Docket Item # 2
BAR CASE #2011-0363

BAR Meeting
February 1, 2012

ISSUE: Certificate of Appropriateness (storefront reconfiguration)
APPLICANT: East Banc, Inc. by Robert M. Gurney, FAIA
LOCATION: 326 King Street
ZONE: KR/King Street Retail

STAFF RECOMMENDATION: Staff recommends approval of the Certificate of Appropriateness for scheme 1, with the following conditions:

Figure 8: Proposed exterior light fixture.

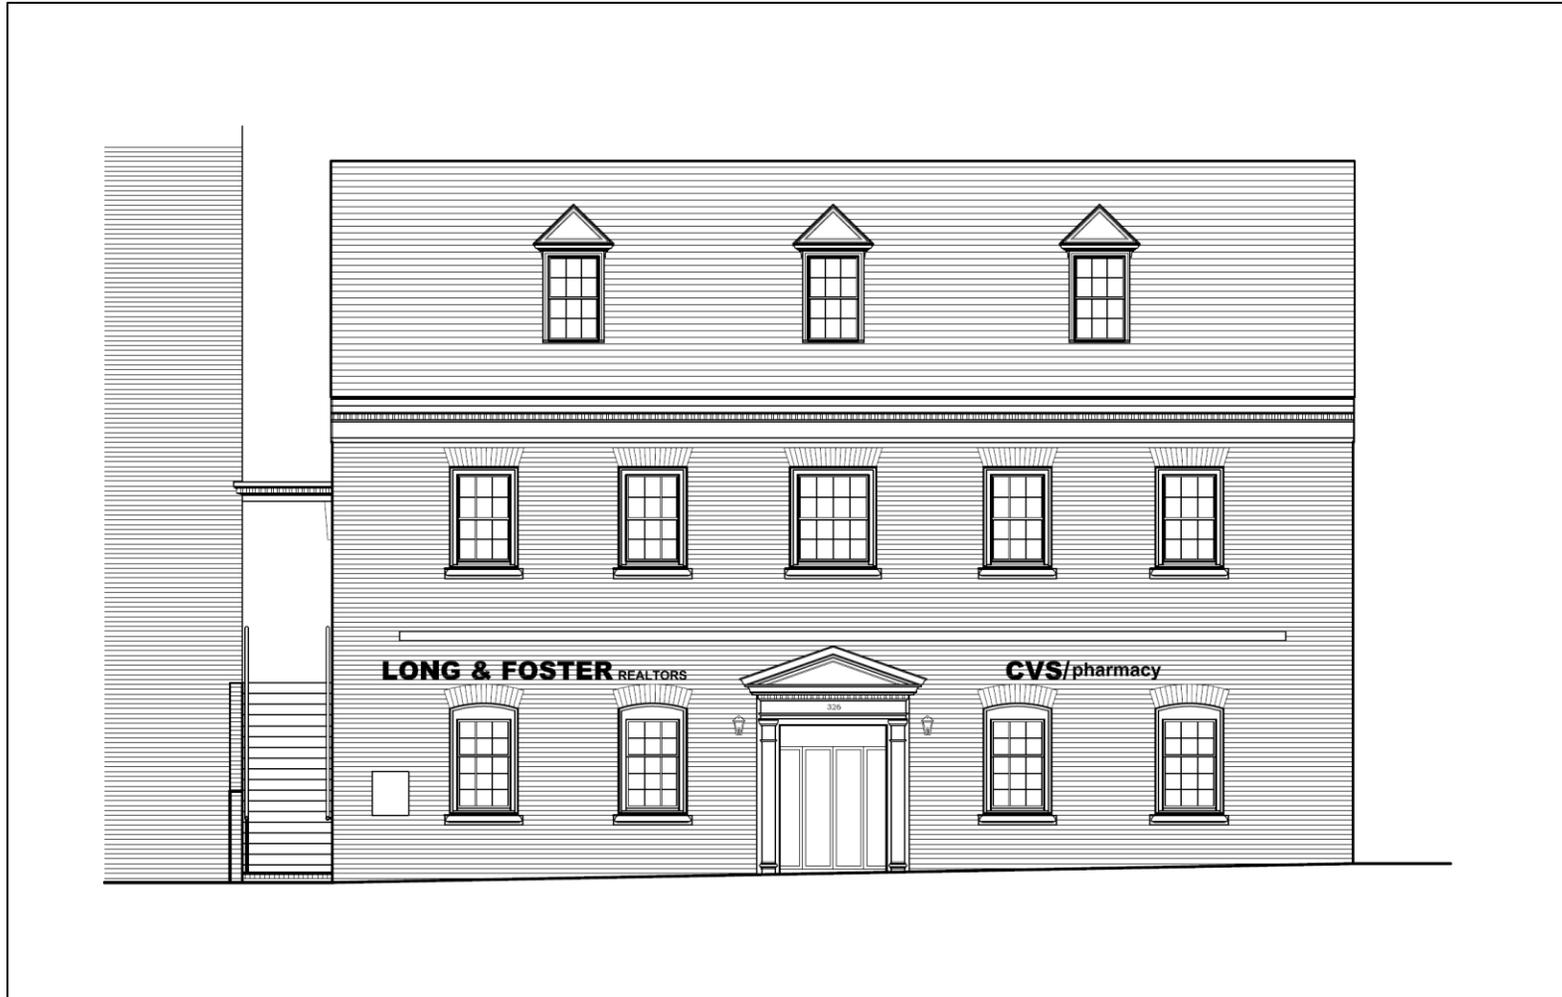
The applicant is proposing that new exterior light fixtures flank each side of the new openings, creating a repetitive rhythm down the front façade (figure 8). These light fixtures are untreated copper and will achieve full patina over time. The fixtures will extend 17.5" from the wall and are 8.5" tall with a 100W incandescent bulb. Staff feels these high quality light fixtures conform to the *Design Guidelines*, and therefore, supports their installation.
